Rezoning Transportation Analysis

Petition Number: 2019-126

General Location Identifier: 08107206, 08107202, 08107207

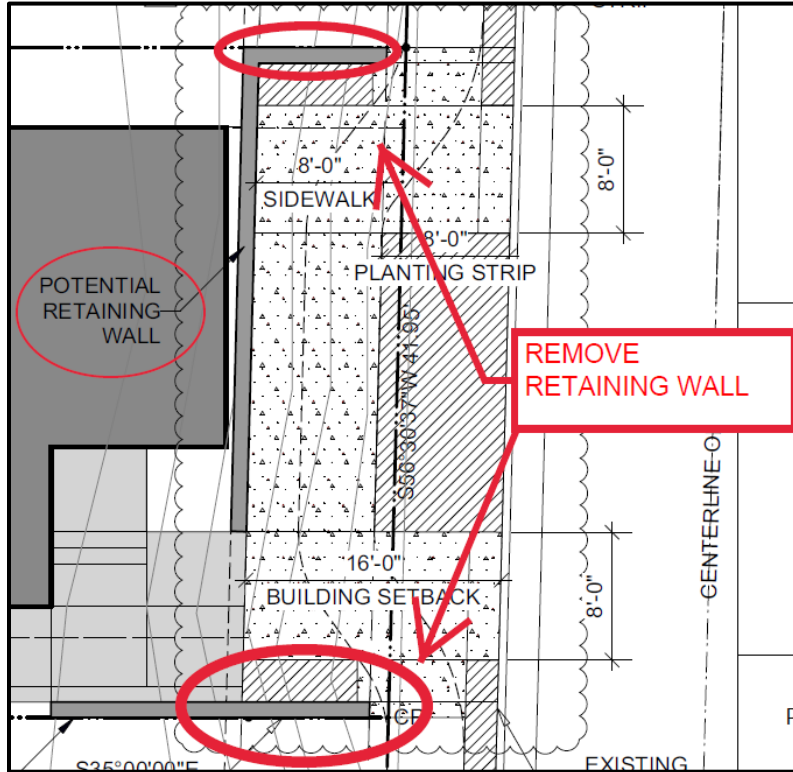
8. **New Comment based on Revised Site Plan (03-25-2020)** The petitioner should revise the site plan and conditional note(s) to remove the retaining walls from N. Davidson at the end of the sidewalk as it will create cost for the City to extend the sidewalk in the future.

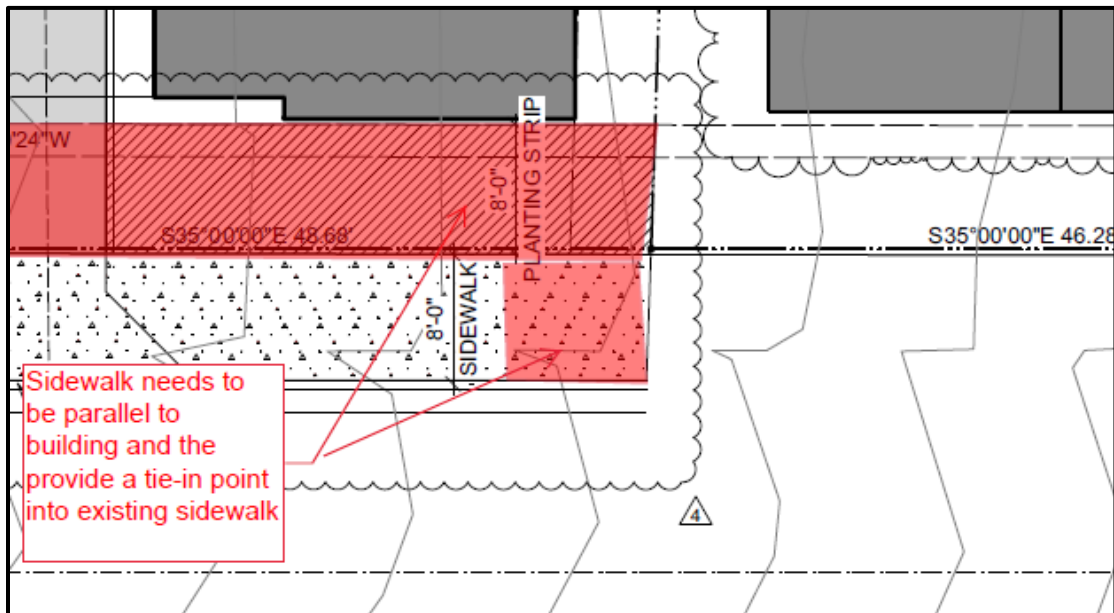
9. **New Comment based on Revised Site Plan (03-25-2020)** The petitioner should revise the site plan and conditional note(s) to provide sidewalk transition to existing sidewalk on two different location along 17th Street.

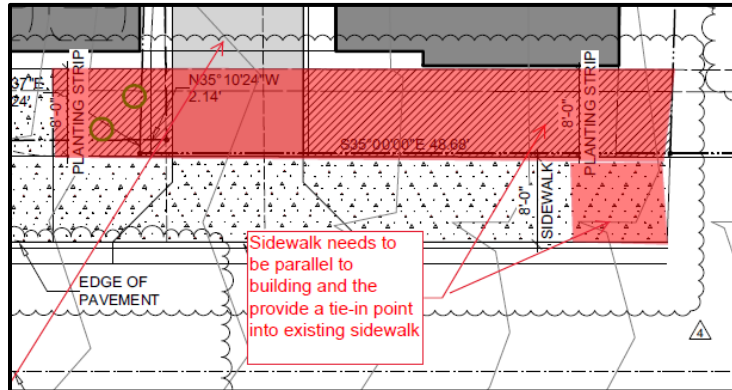
10. **New Comment based on Revised Site Plan (03-25-2020)** The petitioner should revise the site plan and conditional note(s) to provide the required 8-foot and 8-foot sidewalk along the entire frontage on 17th Street.

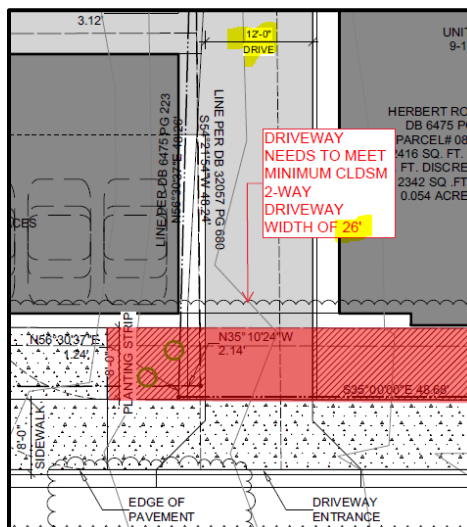
11. **New Comment based on Revised Site Plan (03-25-2020)** The petitioner should revise the site plan and conditional note(s) to provide the required [Charlotte Land Development Standards Manual Driveway](#) detail 10.25A width for a two-way driveway having access to a public street on 17th Street.
